Comment (#167):

(TDL #385 D2.2)

**Comment: Do we need the spec for Irms in 145.3.8.4?**

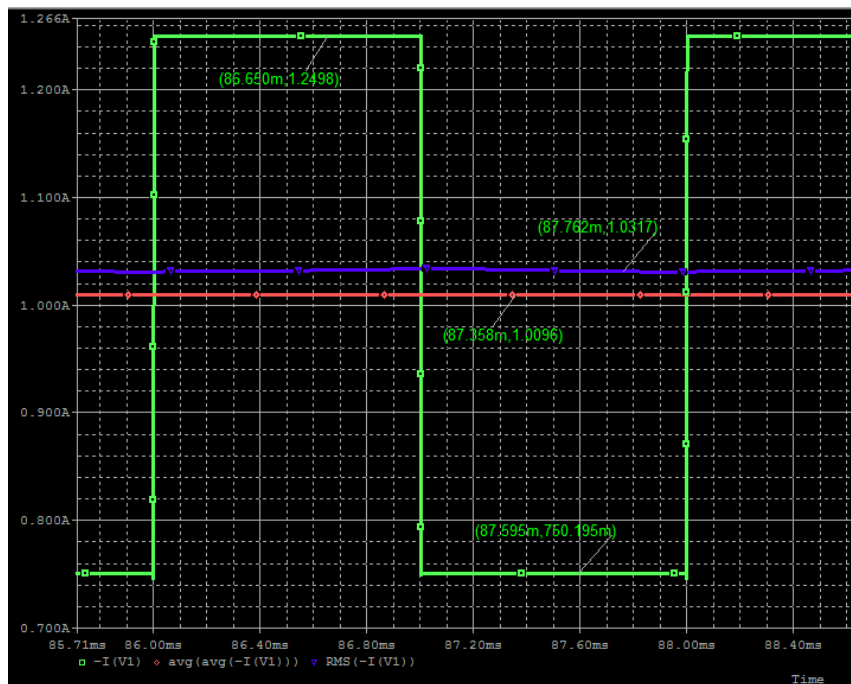
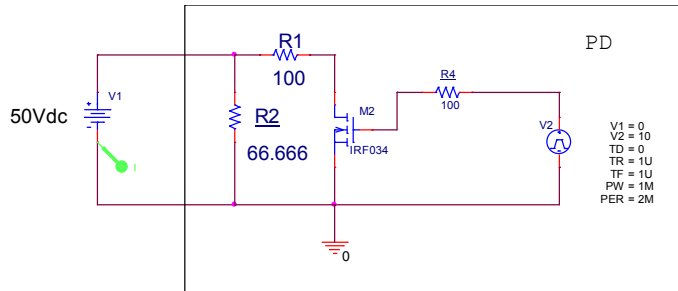
In order to prevent excessive heat to PSE and PD components due to the fact that RMS value > AVG values, when we define limits for parameters that are current, we need to measure its RMS content and not their DC content.

The issue is lake of awareness that a DC current measurement is misleading.

**The rule is: in a definition such  $Icon = Pclass\_PD / Vpd-2P$ , Icon is the RMS value and not the average value for correct measurements and calculations.**

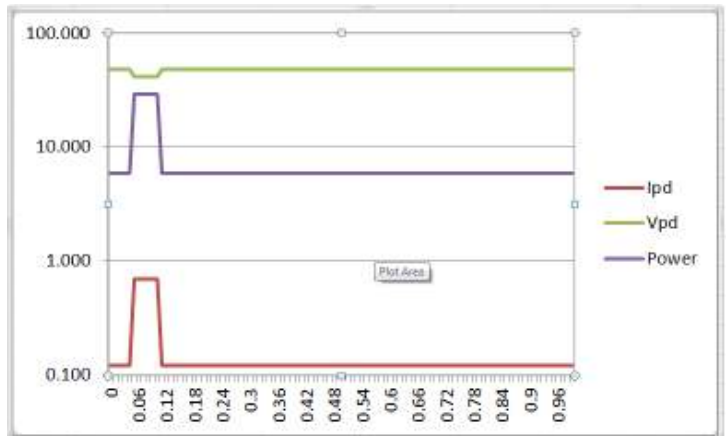
- The following “PD” is consuming 0.75A plus additional 0.5A pulses at duty cycle of 50%.
- Resulting with peak current of 1.25A and valley value of 0.75A.

1. The average current is:  $I_{avg} = 0.5 \cdot (0.75A + 0.5A) + 0.5 \cdot 0.75A = 1A$
2. The RMS current is:  $I_{rms} = \sqrt{0.5 \cdot (0.75A + 0.5A)^2 + (0.5 \cdot 0.75A^2)} = \sim 1.03A$
3. The **average power** delivered from the source equal to the average power delivered to the load:  
 $P_{avg} = V_{pse} \cdot I_{avg} = 50V \cdot 1A = 50W$
4. The **RMS power** dissipated at the PD is  $Duty \cdot R1 \cdot I_{rms}^2 + R2 \cdot I_{rms}^2 = 0.5 \cdot 100\Omega \cdot (1.03A)^2 + 66.666\Omega \cdot (0.75A)^2 = 50W$

**In this case  $P_{rms} = P_{avg}$  only because we did it correctly when mixing DC voltage with average current through the load.**
